**STATE OF TENNESSEE
DEPARTMENT OF TRANSPORTATION**

INSTRUCTIONAL BULLETIN NO. 17-09

Regarding Revised Standard Drawings

Effective February 9th, 2018 letting (November 29th, 2017 Turn-in), the following Standard Drawings have been revised. Also, Section 5, Index of Standard Drawings, of the Roadway Design Guidelines has been revised to incorporate these changes.

D-PB-1

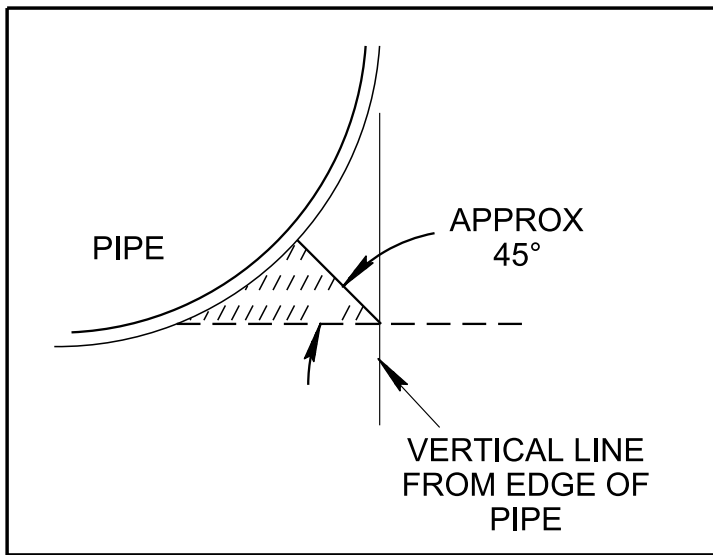
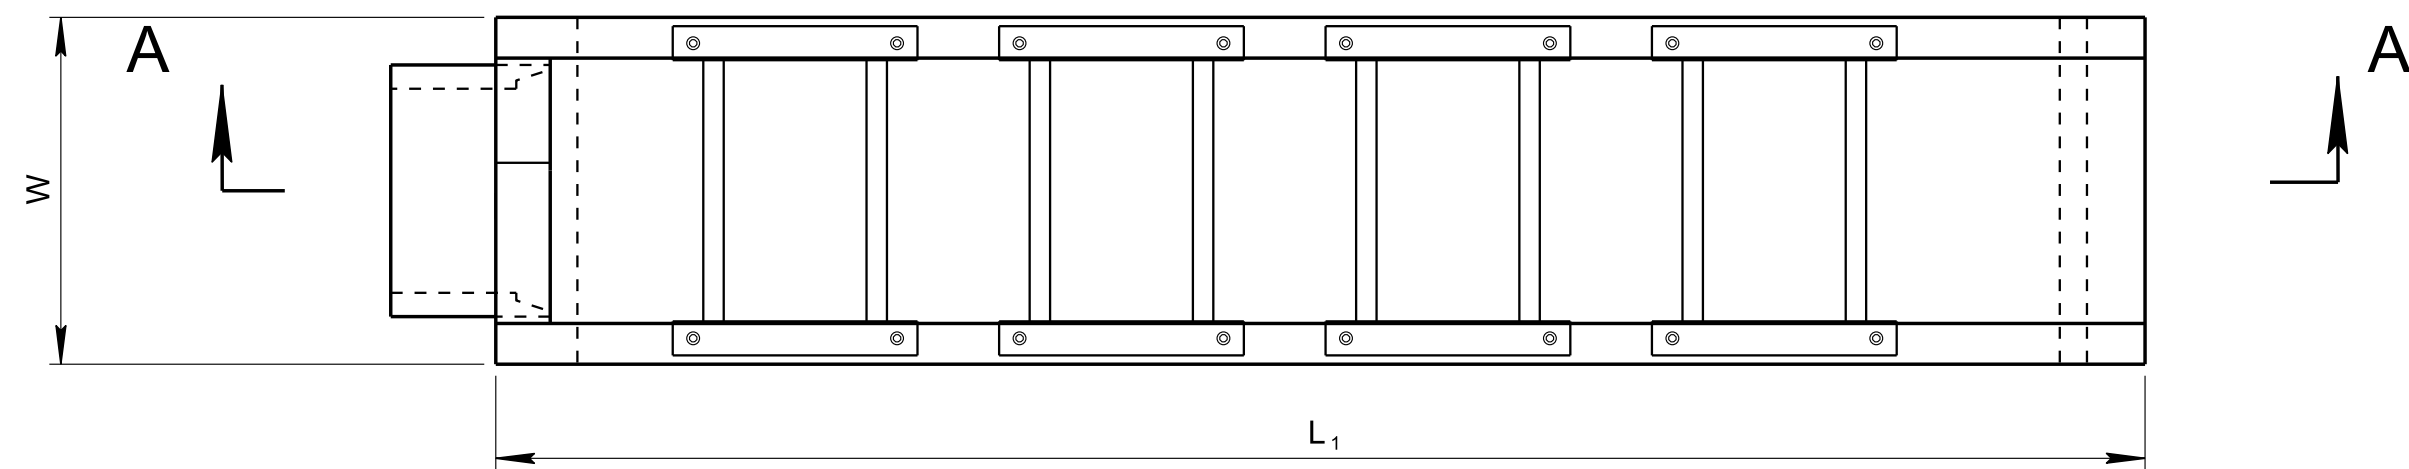
- REV. 7-12-07: REVISED GENERAL NOTE (J)
- REV. 6-1-09: REVISED GENERAL NOTE (I) AND TITLE NAME. ADDED GENERAL NOTE (J)
- REV. 2-1-12: REVISED DRAWING NAME ADDED EFF DETAIL. REVISED GENERAL NOTES AND TABLE. ADDED MINIMUM COVER TABLE.
- REV. 8-21-12: REVISED GENERAL NOTES. CHANGED BACKFILL MATERIAL.
- REV. 1-2-13: REVISED TRENCH DETAILS REVISED BEDDING TABLE.
- REV. 3-16-17: CLARIFIED PAYMENT ITEM NO. IN TABLE B.

D-SEW-1A

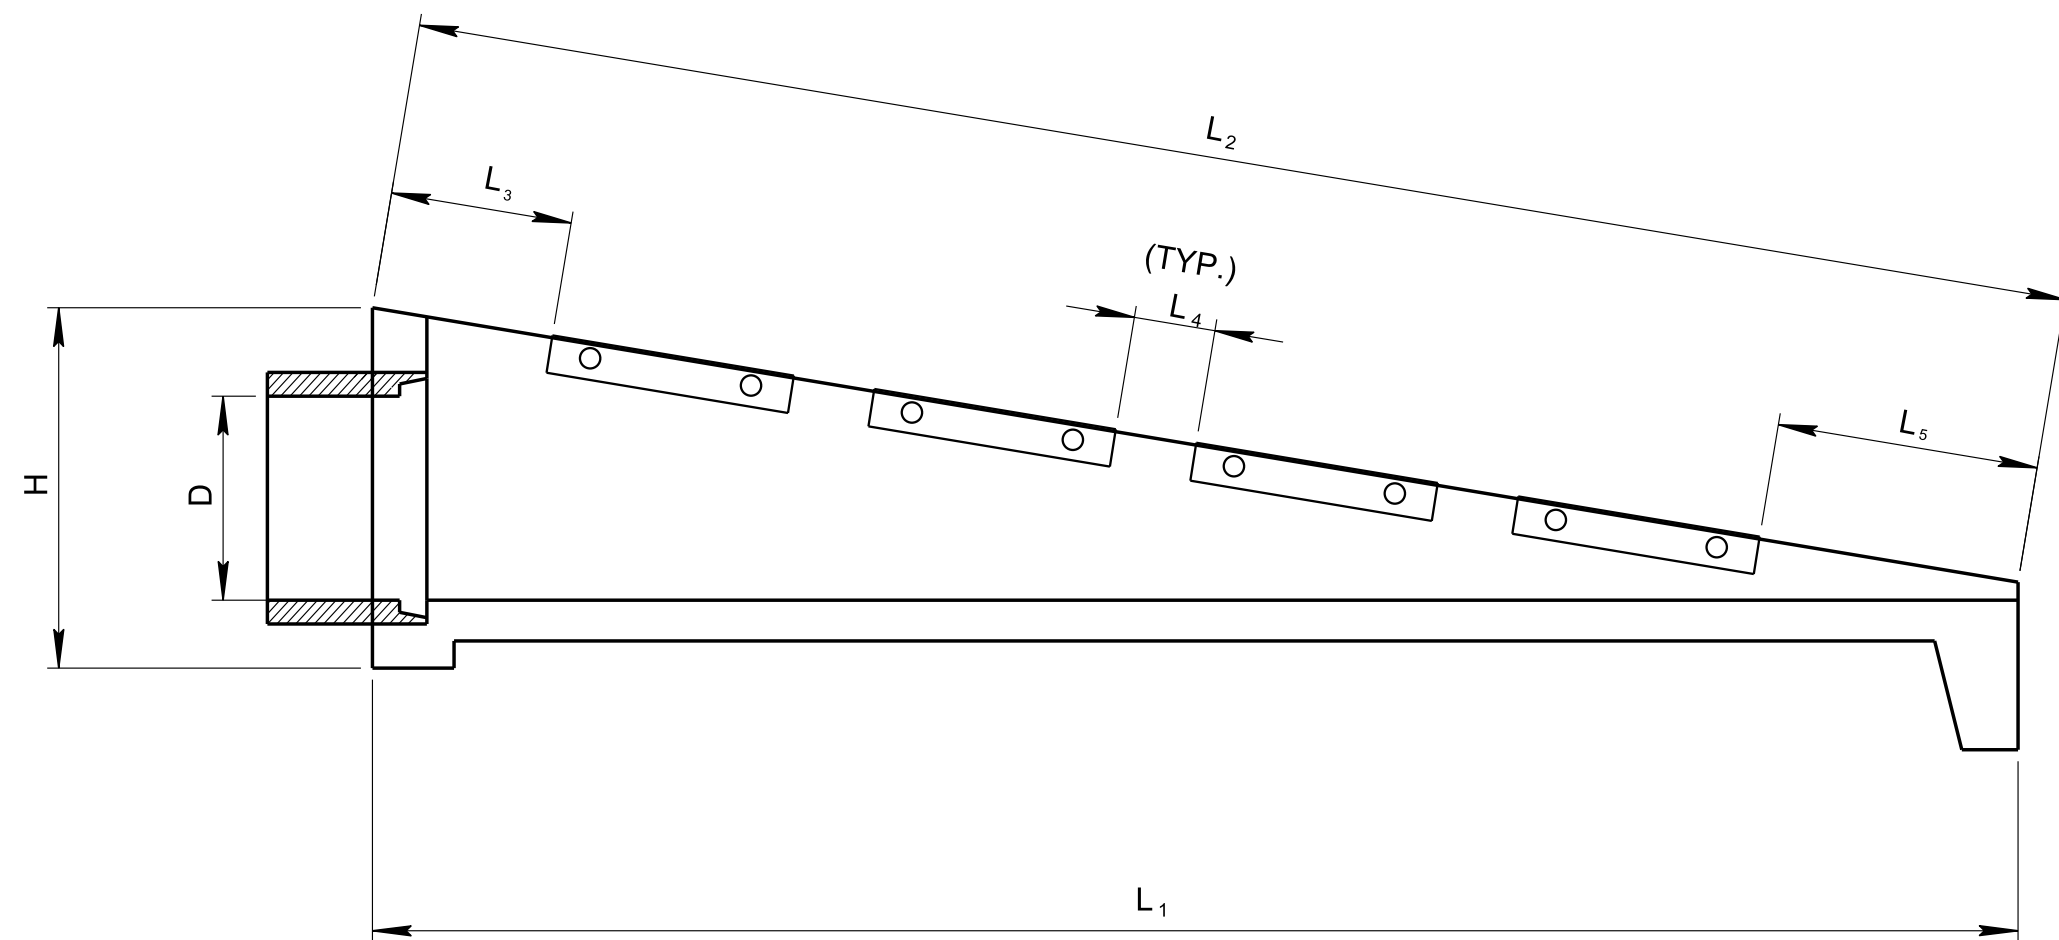
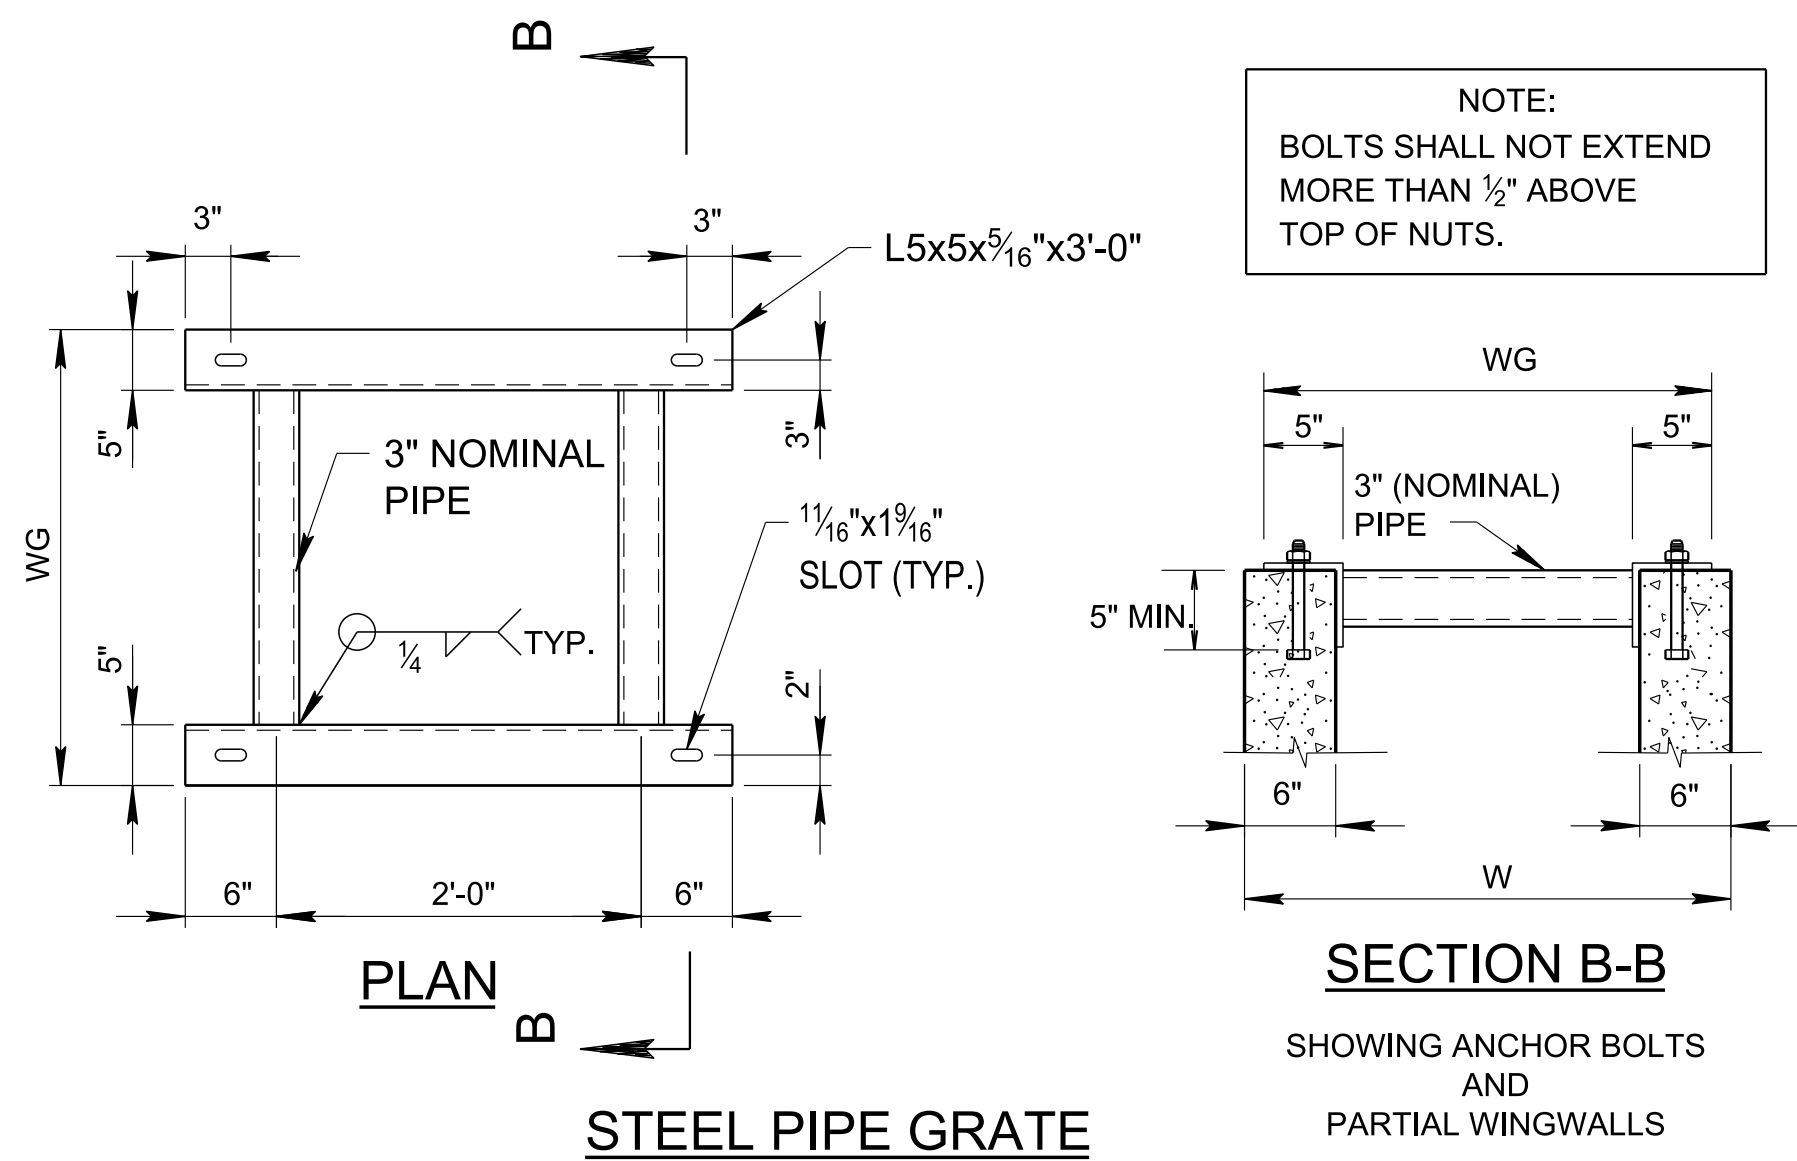
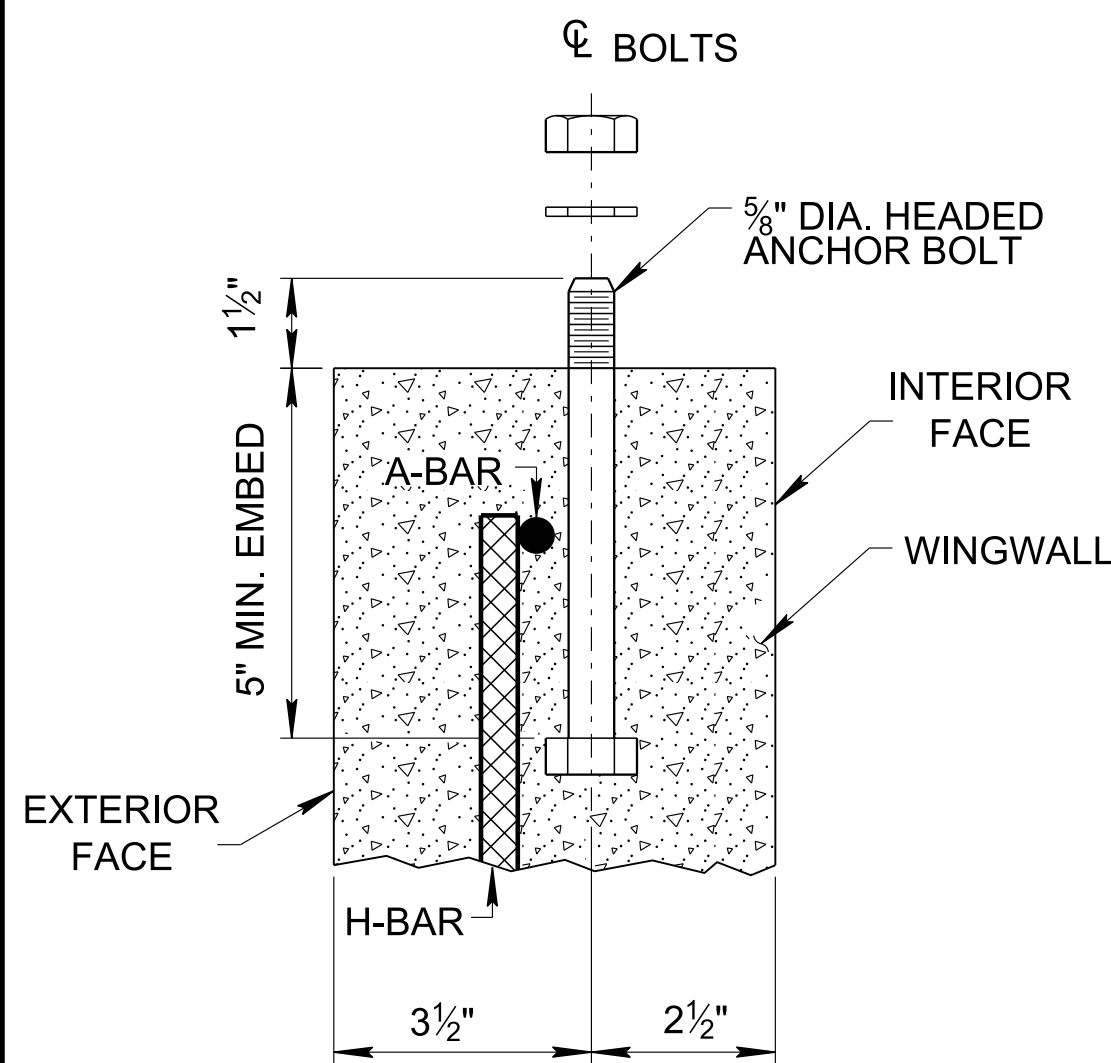
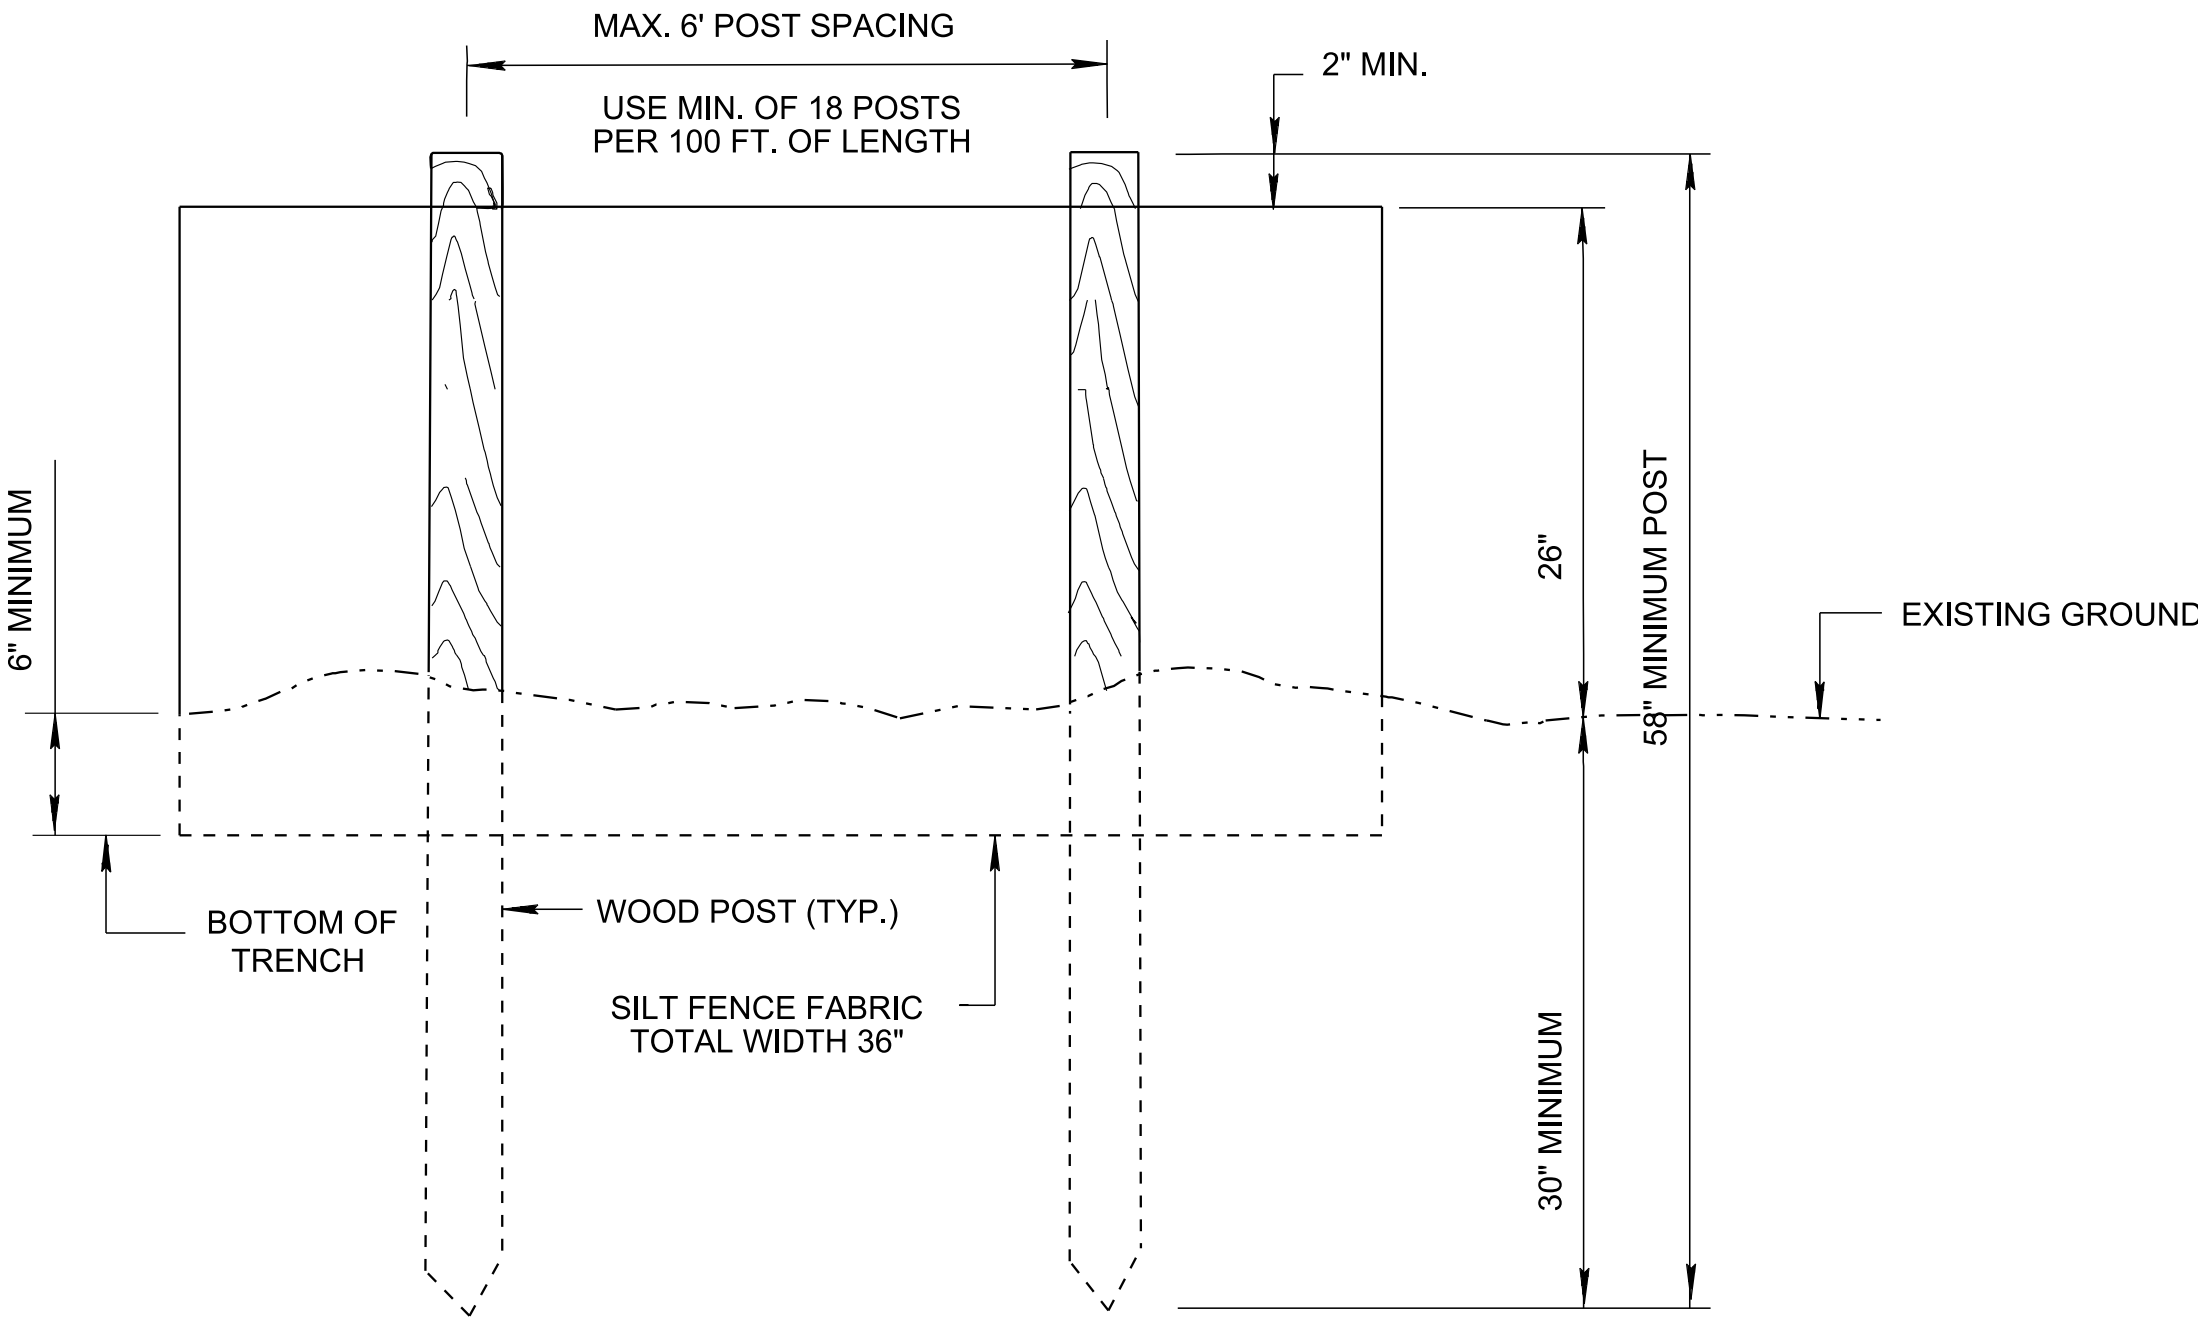
- REV. 7-10-12: REVISED ALTERNATE ANCHORS FOR STRUCTURAL STEEL GRATES NOTE.
- REV. 1-10-13: CHANGED REQUIREMENT FOR GRATE ON ALL ENDWALLS.
- REV. 6-14-13: REVISED NOTE E, ADDED NOTES (F) AND (G).
- REV. 3-16-17: REVISED GENERAL NOTES. ADDED FOOTNOTE TO TABLE.
